HYATT PLACE HOTEL AT ROCK FINANCIAL SHOWPLACE – SP 08-27

HYATT PLACE HOTEL AT ROCK FINANCIAL SHOWPLACE, SITE PLAN NUMBER 08-27

Public Hearing of the request of Titan Hotel Development, LLC, for a recommendation to City Council for Preliminary Site Plan, Wetland Permit, Woodland Permit, and Stormwater Management Plan approval. The subject property is located in Section 16, north of Grand River Avenue, west of Taft Road, in the OST, Planned Office Service Technology District with an EXO, Exposition Overlay. The subject property is approximately 54.86 acres and the applicant is proposing to construct a 5-story, 132-room Hyatt Place hotel and an expansion of the parking lot on the site of Rock Financial Showplace.

Attachment:
Revised conceptual layout for loading zone area

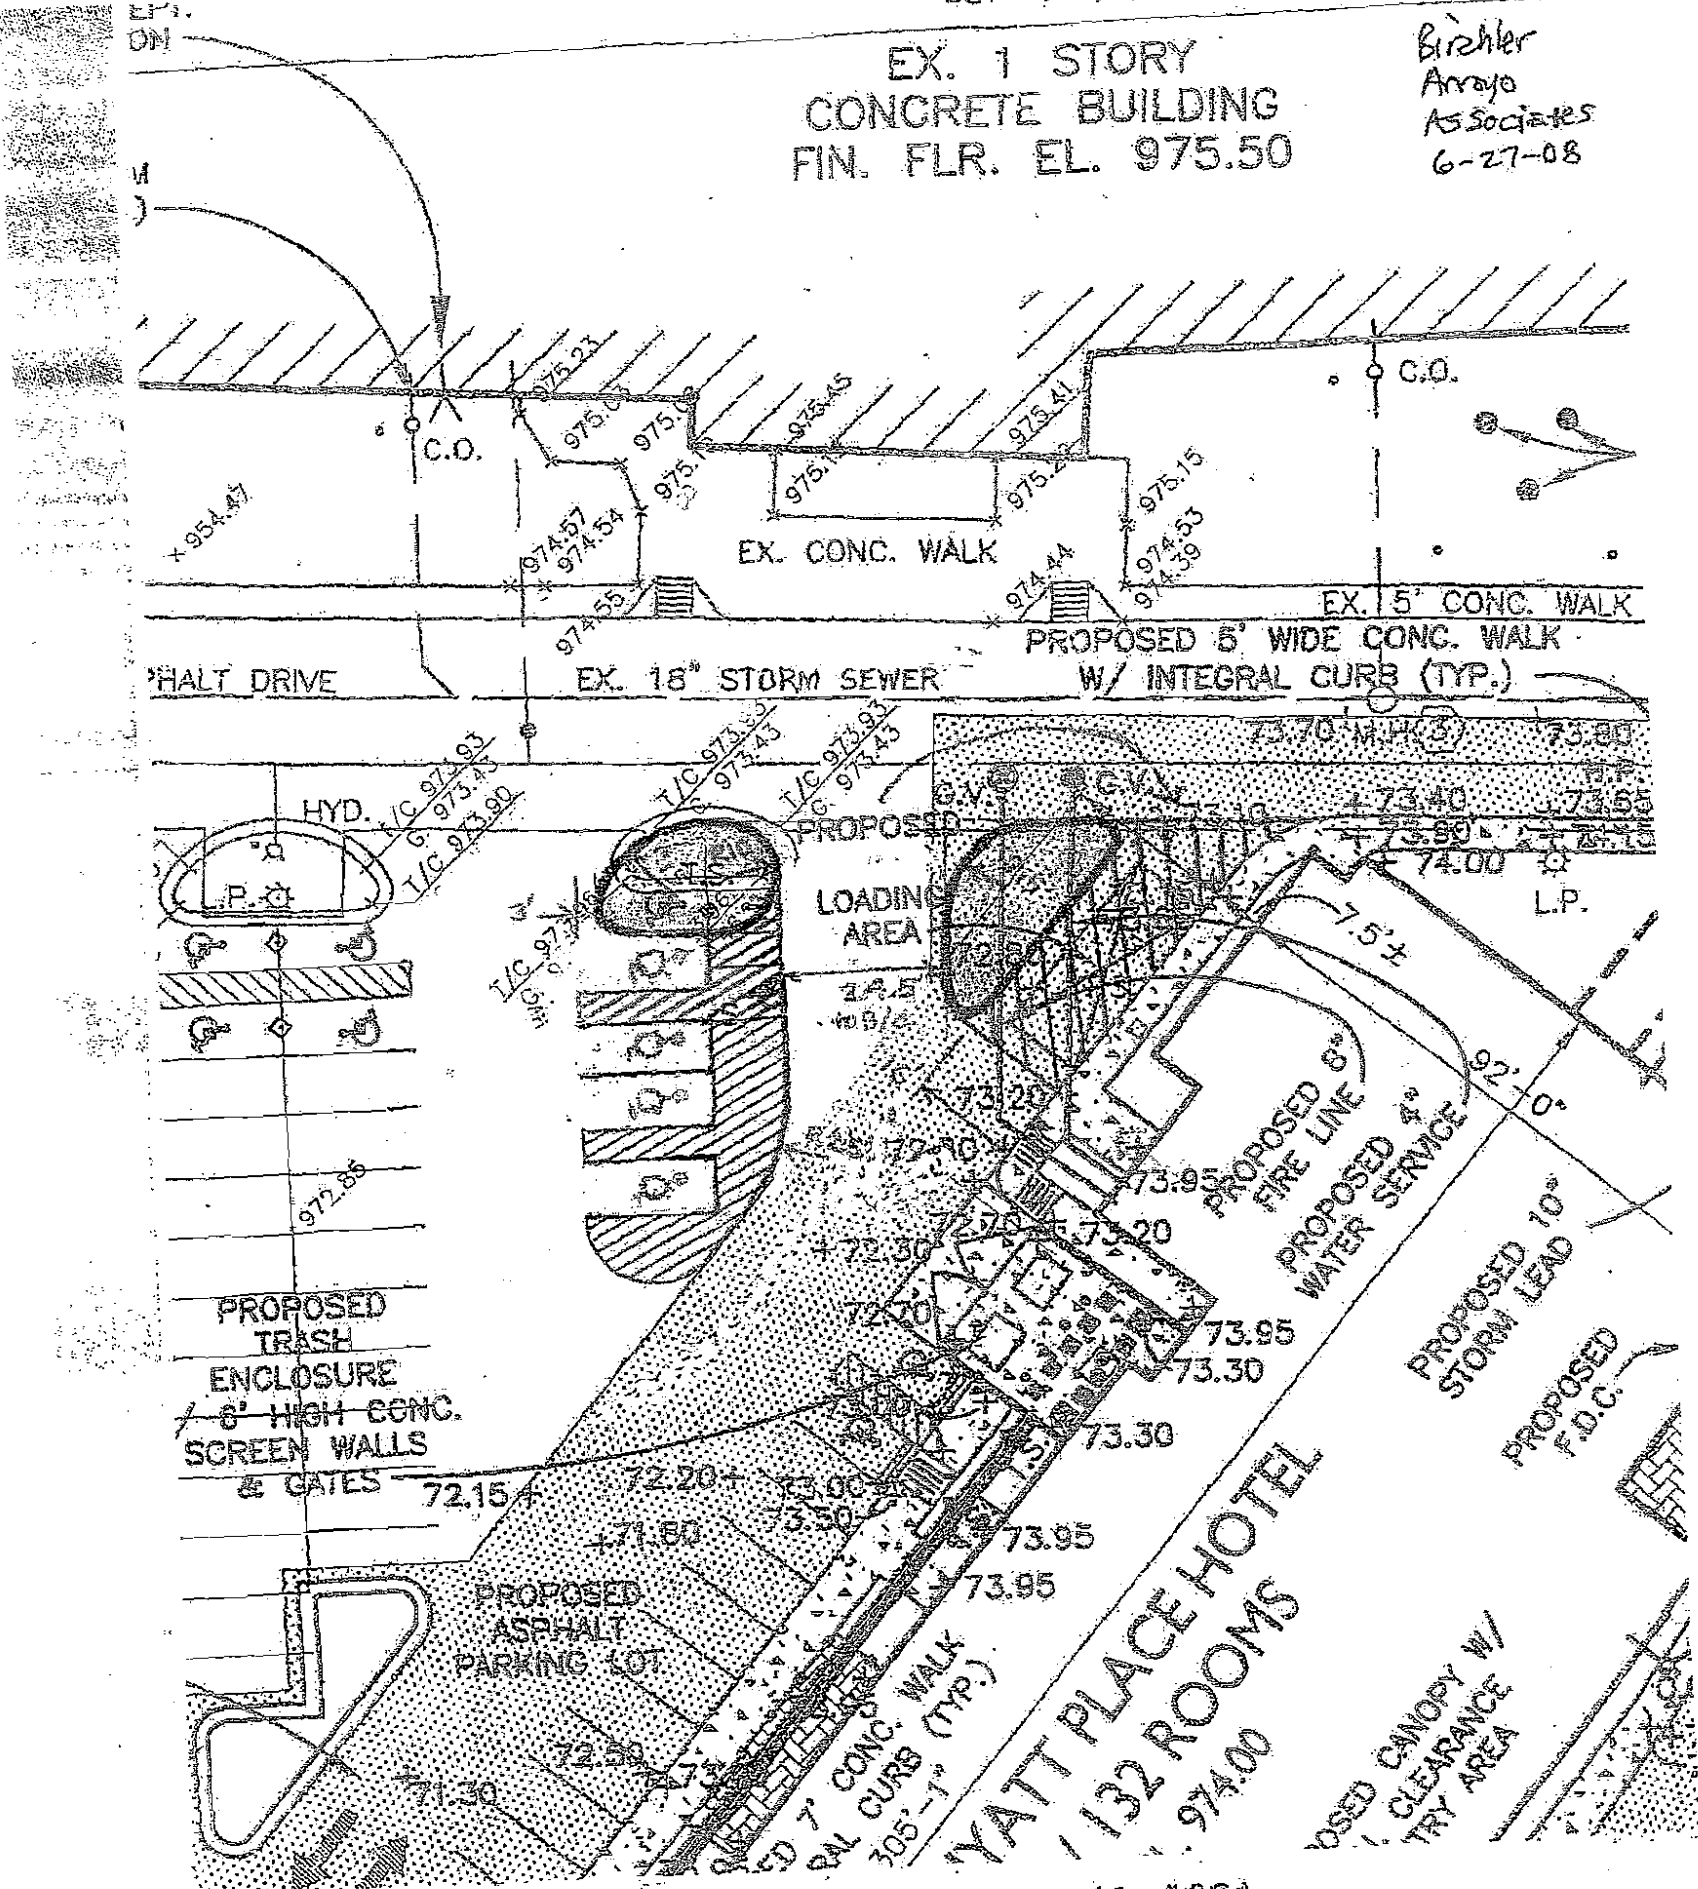
- 13. We have provided a rendering of our proposed layout for the loading zone near the northwest corner of the site. We believe that this design better directs traffic flow while separating the loading zone from the maneuvering lane. It also improves sight distance while the loading zone is in use. The design would allow front-loading refuse vehicles to access the trash enclosure on the west side of the proposed building. **This design should be incorporated into the final site plan.** We would be willing to conduct an advance informal review of the applicant's inclusion of our design into their site plan should they desire.
